ENGINEERING BULLETIN

Ref Document No.	EB15012	Issue No.	1
Subject	Coolant Loss and Engine Oil Pressure Test Tap		
Release Date	20 th July 2015

Purpose – Advise COALTRAM® owners of changes to the mounting of the coolant loss and oil pressure test taps.

Applicability – COALTRAM® models - CT08, CT10, CT10LP and CT13

Figure 1

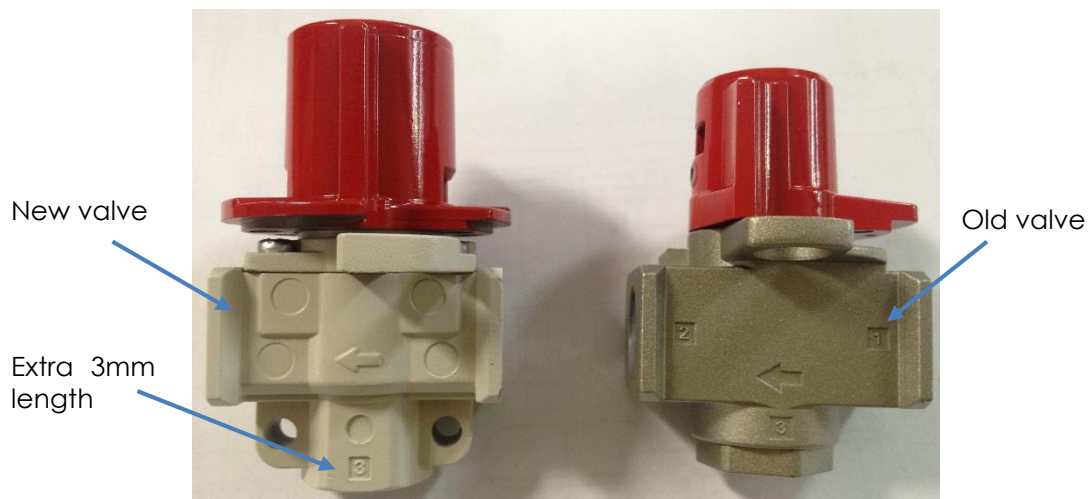
PPK's supplier of the coolant loss and oil pressure test taps (PPK part number 5520000160) has released a new version of the valve. The shape of the valve has been modified making it 3mm larger in one direction. The older revision of the valve is no longer available for sale. As a consequence if a replacement valve is ordered for an existing Coaltram the new valve will not be able to be installed without modifying the bracket in which it is housed or purchasing and installing a new bracket (part number 5520001750).

The difference between the valves can be seen in figure 1 below.

Figure 2

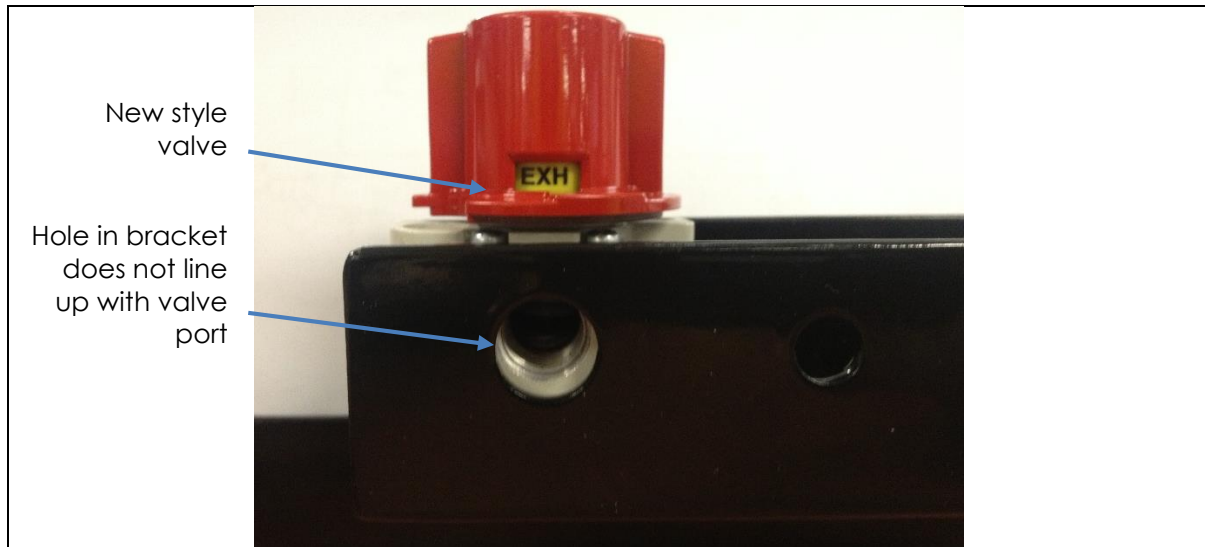
The extra 3mm causes the cross flow ports (ports 1 and 2) not to line up with the mounting holes in the bracket. This can be seen in figure 2 below. The holes in the existing bracket will require elongating in order to be able to install the fittings to the valve. Alternatively a new replacement bracket can be purchased from PPK (part number 5520001750).

PPK recommend elongating the holes in the test tap bracket or replacing the bracket (part number 5520001750) only when replacing a coolant loss or engine oil pressure test tap (part number 5520000160) for the first time with the new larger test tap.

Figure 3

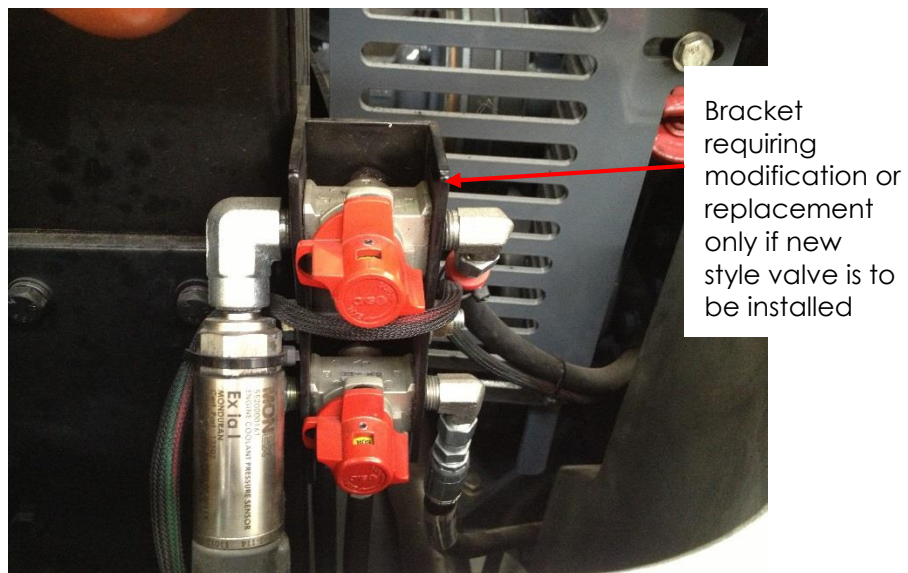
Installed on the Coaltram, these test taps are found mounted to the side of the radiator cowl on the off drivers side (see figure 3).
